METRO BUILDING SUPPLY ADDITION

RE: SUB 2004-74 -- One-Step Final Plat of Metro Building Supply Addition

RE: SUB 2004-74 -- One-Step Final Plat of Metro Building Supply Addition

CASE NUMBER: SUB 2004-74 -- METRO BUILDING SUPPLY ADDITION

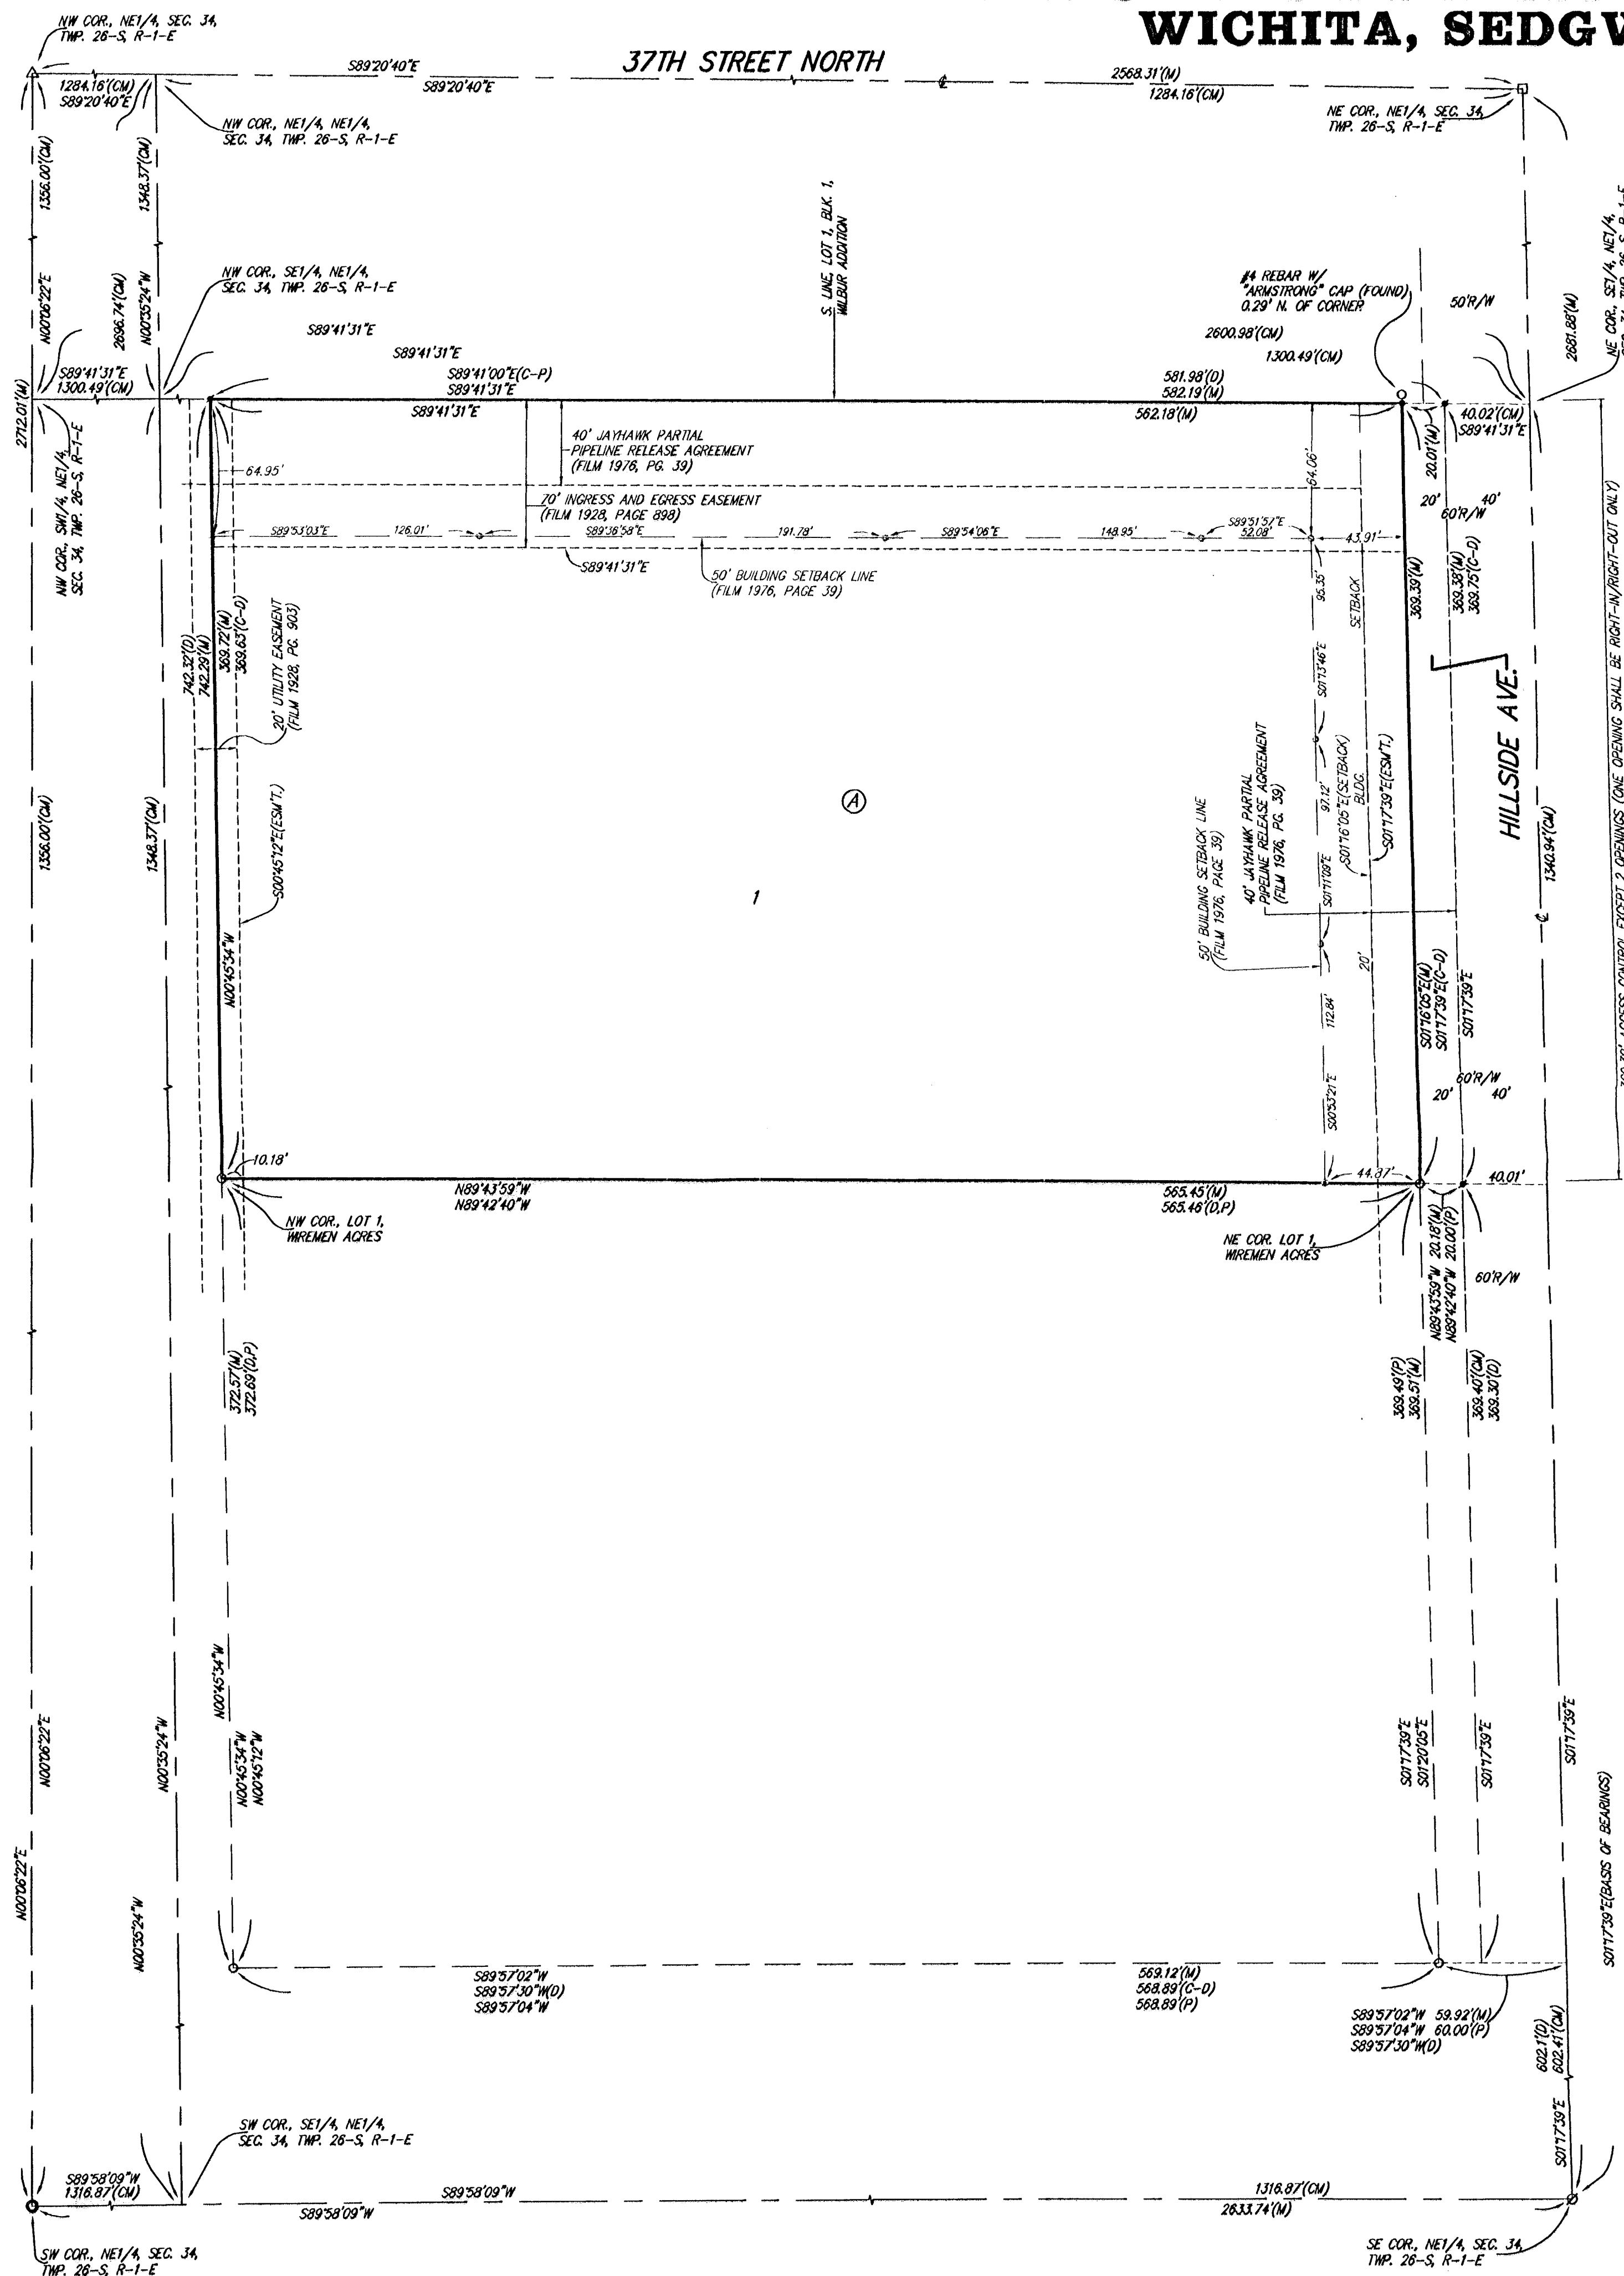
- A. The applicant shall guarantee the extension of sanitary sewer and City water to serve the lots being platted. City Engineering needs to comment on the need for other guarantees or easements.

- C. City Engineering needs to comment on the status of the applicant's drainage plan. The drainage plan is approved.
- D. The plat proposes two street openings to Hillside. Traffic Engineering has approved one opening with full turning movements, another opening limited to right turns in-out only. A note shall be placed on the plat regarding access controls being in accordance with the Access Management Regulations.

- E. Traffic Engineering has requested a petition for left and right turning lanes.
- F. This property is within a zone identified by the City Engineers' office as likely to have groundwater at some or all times within 10 feet of the ground surface elevation. Building with specially engineered foundations or with the lowest floor opening above groundwater is recommended, and owners seeking building permits on this property will be similarly advised. More detailed information on recorded groundwater elevations in the vicinity of this property is available in the City Engineers' office.

- G. The applicant shall submit a copy of the instrument which establishes the pipeline easements on the property, which verifies that the easements shown are sufficient and that utilities may be located adjacent to and within the easements. Any relocation, lowering or encasement of the pipeline, required by this development, will not be at the expense of the City.

- H. The applicant's agent shall determine any setback requirements for the pipelines by researching the text of the pipeline agreements. If a setback from the pipeline easements is provided for in the pipeline easement agreements, it shall be indicated on the face of the plat.

- I. The plat's text shall include language that a drainage plan has been developed for the plat and that all drainage easements, rights-of-way, or reserves shall remain at established grades or as modified with the approval of the applicable City or County Engineer, and unobstructed to allow for the conveyance of stormwater.

- Q. The representatives from the utility companies should be prepared to comment on the need for any additional utility easements to be platted on this property.
